# APPROVED MINUTES

## May 18, 2023 Standards Committee Meeting

RE: Minutes from the May 18, 2023 Standards Committee Meeting

PROPOSED FIGURE TO BE SHOWN IN GENERAL INSTRUCTIONS TO FIELD EMPLOYEES (GIFE)

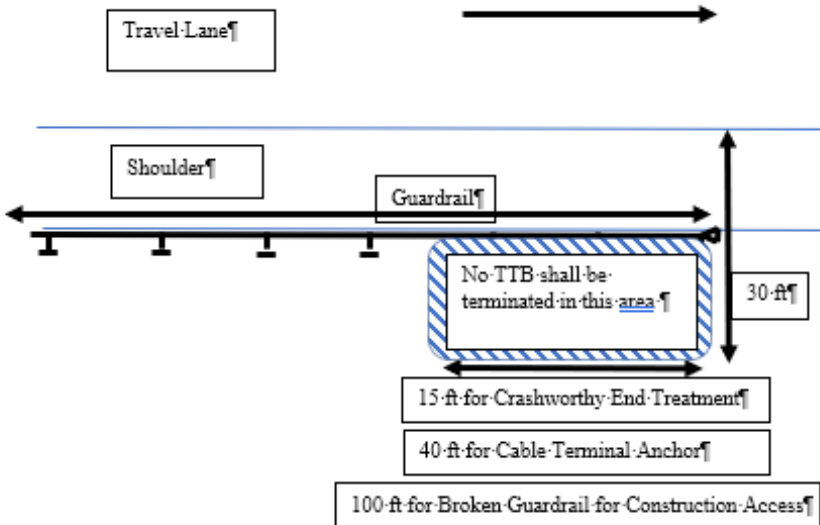
Where temporary traffic barrier is terminated behind guardrail within 30 ft from the edge of the adjacent travel lane, the ends of the TTB shall not be within 10 feet of the face of guardrail, and the TTB shall overlap:

- → a crashworthy guardrail end treatment by more than 15 ft,
- → a guardrail cable terminal anchor by more than 40 ft, or
- → a run of guardrail that has been broken for construction access by more than 100 ft.

No portion of the temporary traffic barrier shall be within 10 ft behind the face of guardrail.
